SUBJECT: SURRY UNITS 1 AND 2 - ISSUANCE OF AMENDMENTS RE: ASME CODE
REQUIREMENTS FOR MAIN STEAM AND FEEDWATER SYSTEMS (TAC NOS.
M97908 AND M97909)

AMENDMENT NO. 212 TO FACILITY OPERATING LICENSE NO. DPR-32 - SURRY UNIT 1
AMENDMENT NO. 212 TO FACILITY OPERATING LICENSE NO. DPR-37 - SURRY UNIT 2

ATTACHMENT TO LICENSE AMENDMENT
AMENDMENT NO. 212 TO FACILITY OPERATING LICENSE NO. DPR-32
AMENDMENT NO. 212 TO FACILITY OPERATING LICENSE NO. DPR-37
DOCKET NOS. 50-280 AND 50-281

AUGMENTED INSERVICE INSPECTION PROGRAM FOR HIGH ENERGY LINES OUTSIDE OF CONTAINMENT

MAIN STEAM AND FEEDWATER LINES - UNIT 2
SURRY POWER STATION
UNITS 1 AND 2

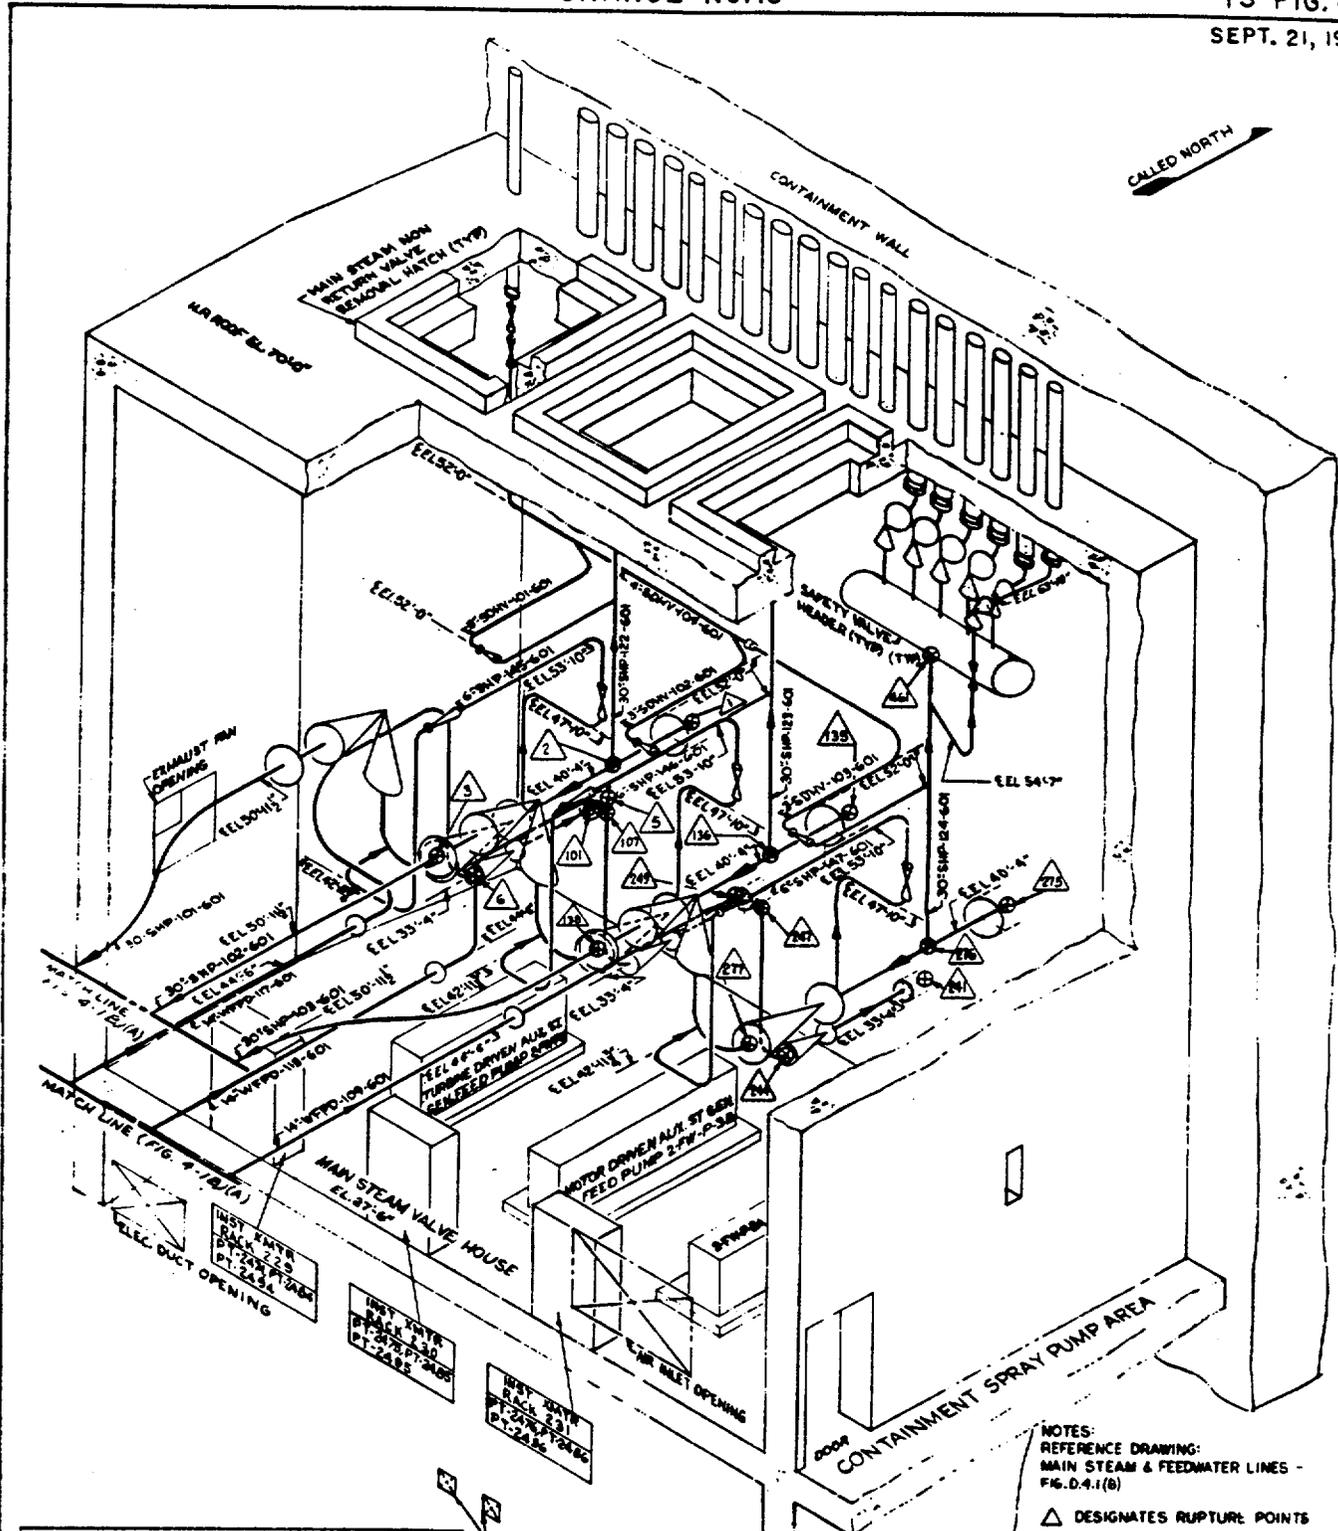
Additionally, subsequent to the February 3, 1997 submittal, it was identified that pages TS 4.15-1, TS 4.15-3, and TS Fig. 4.15 were inadvertently omitted in previous amendments (Amendments 39 and 40) to the Surry, Unit 1 and Unit 2 TS. Therefore, for the purpose of clarity, in addition to the specific proposed change noted above, TS 4.15 has been revised to include those pages which were inadvertently omitted.

- A. For the 20 welds identified in TS Figure 4.15:
1. At the first refueling outage period a volumetric examination shall be performed with 100 percent inspection of welds in accordance with the requirement of ASME Section XI Code, Inservice Inspection of Nuclear Power Plant Components, to

- B. For all welds other than those identified in TS Figure 4.15:
1. Welds in the main steam lines including the safety valve headers and in the feedwater lines in the main steam valve house shall be examined in accordance with the requirements of subsection IWC of the ASME Section XI Code.
